Access Compliance Report

Public Rights-of-Way

(Curb Ramps)

Intersection ID: 12620	Main Street: JOHN_CROSLAND_JR_DR	Cross Street: HARGROVE_AV	Location: NW
ADA ID: 144DAD91BF48	Ramp Type: PerpDiag	Initial Pass/Fail: Fail	Overall Compliance: No
Severity Score: 33.75			
Codes/Mitigation Info/Possible Solution		Field Measurements/Component Compliance

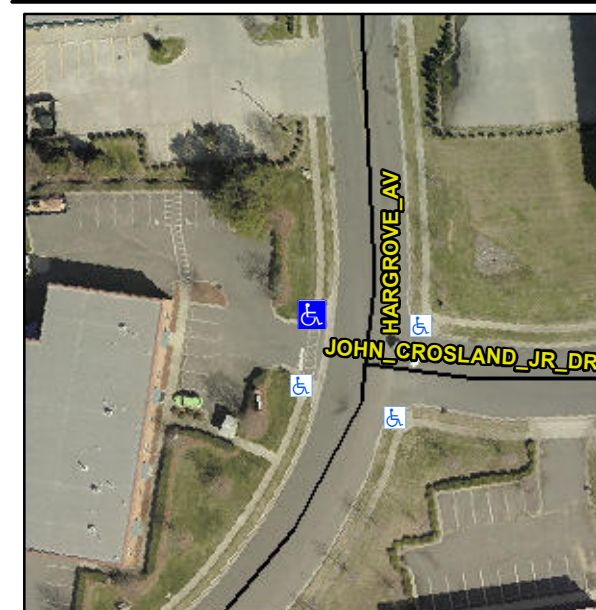
PROW/ADA:

R304.5.1, R304.2.2

Compliance	Description	Data	Compliance	Description	Data
N/A	Ramp Length (in)	35.0	No	Ramp Slope (%)	13.4
No	Ramp Width (in)	36.0	Yes	Ramp XSlope (%)	0.6
N/A	Flare Type LT	N/A	N/A	Flare Type RT	N/A
N/A	Flare Slope LT (%)	N/A	N/A	Flare Slope RT (%)	N/A
N/A	Flare Traversable LT?	N/A	N/A	Flare Traversable RT?	N/A
N/A	Landing Length (in)	N/A	N/A	DWS Provided?	N/A
N/A	Landing Width (in)	N/A	N/A	DWS Contrast?	N/A
N/A	Landing Slope (%)	N/A	N/A	DWS Length (in)	N/A
N/A	Landing X Slope (%)	N/A	N/A	DWS Full Width?	N/A
N/A	Landing Curb? (Y/N)	N/A	N/A	DWS Offset (in)	N/A
N/A	Shared Landing?	N/A			
N/A	Gutter Ponding?	N/A	N/A	Gutter Slope (%)	N/A
N/A	Gutter Lip Ht (in)	N/A	N/A	Gutter X Slope (%)	N/A
N/A	Painted X Walk1?	Yes	N/A	Painted X Walk2?	No
	X Walk 1 Direction	To S		X Walk 2 Direction	To E
N/A	X Walk 1 Width (in)	55.0	N/A	X Walk 2 Width (in)	N/A
	X Walk 1 Slope (%)	4.2		X Walk 2 Slope (%)	3.3
	X Walk 1 X Slope (%)	0.8		X Walk 2 X Slope (%)	2.3

N/A	Ramp inside XWalk1?	Yes	N/A	Ramp inside XWalk2?	N/A
	Road Slope (%)	0.7	N/A	Clear Space?	N/A
	Road X Slope (%)	1.4	N/A	Clear Space to XWalk (in)	N/A
N/A	Any Obstructions?	N/A	N/A	Storm Grate/Utility Hazard?	N/A
	Obstruction Type			Storm Grate/Utility Type	
		N/A			N/A
		Yes		Surface Condition? (G/P)	Good

Remove & Replace Curb Ramp With Two New Directional Ramps or Equivalent.
